UNITED STATES PATENT AND TRADEMARK OFFICE

Office Action Summary

10/502,416

DETAILED ACTION

Figure 4

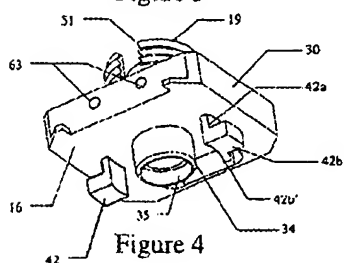
Regarding claim 28, wherein the sleeve mount is made up of two separate accommodating parts, and the means for securing are arranged and retained between the accommodating parts; wherein the sleeve mount is made up of two separate accommodating parts, and the means for securing are arranged and retained between the accommodating parts (See Fig. 4 above).

It would have been obvious at the time the invention was made to a person having ordinary skill in the art to provide bore holes such as the ones shown in Fig. 4 element 63 of

Bull's disclosure and insert the pins through the bore holes in engagement with the slit of the sleeve. **The motivation** for designing a rotational prevention means which engages the slit of the split sleeve is to reduce manufacturing cost by using the same element (sleeve for alignment purpose and locking purpose) for multi-purposes.

Figure 9

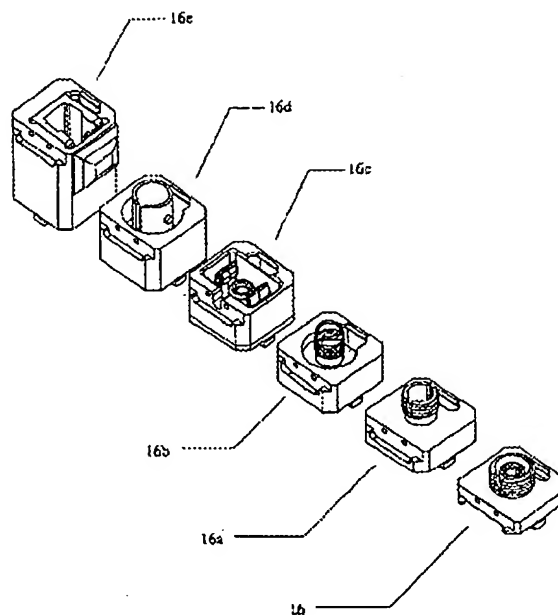
Claim 27, Bull discloses a sleeve mount comprising an interior for accommodating and securing a longitudinally slit (see Fig. 9 '16d'), cylindrical sleeve, the sleeve mount provided in a coupling of an optical plug-in connection for accommodating ferrules of two optical plug-in connectors introduced from opposite directions, the sleeve mount having means for securing the sleeve against rotation about a sleeve axis (see Fig. 8, '38'), wherein the means for securing are arranged in a central part of the sleeve mount and are restricted to the central part of the sleeve mount.

Regarding claims 28 and 36, Bull discloses a sleeve mount comprising an interior for accommodating and securing a longitudinally slit (see Fig. 9 '16d'), cylindrical sleeve, the sleeve mount provided in a coupling of an optical plug-in connection for accommodating ferrules of two optical plug-in connectors introduced from opposite directions, the sleeve mount having means for securing the sleeve against rotation about a sleeve axis (see Fig. 8, '38'), wherein the means for securing are arranged in a central part of the sleeve mount and are restricted to the central part of the sleeve mount; wherein the sleeve mount is made up of two separate accommodating parts, and the means for securing are arranged and retained between the accommodating parts; wherein the sleeve mount is made up of two separate accommodating parts, and the means for securing are arranged and retained between the accommodating parts (See Fig. 4 above). Furthermore, Bull disclose the two mutually opposite ends of the accommodating parts having flange parts butting against one another when the accommodating parts are put together.
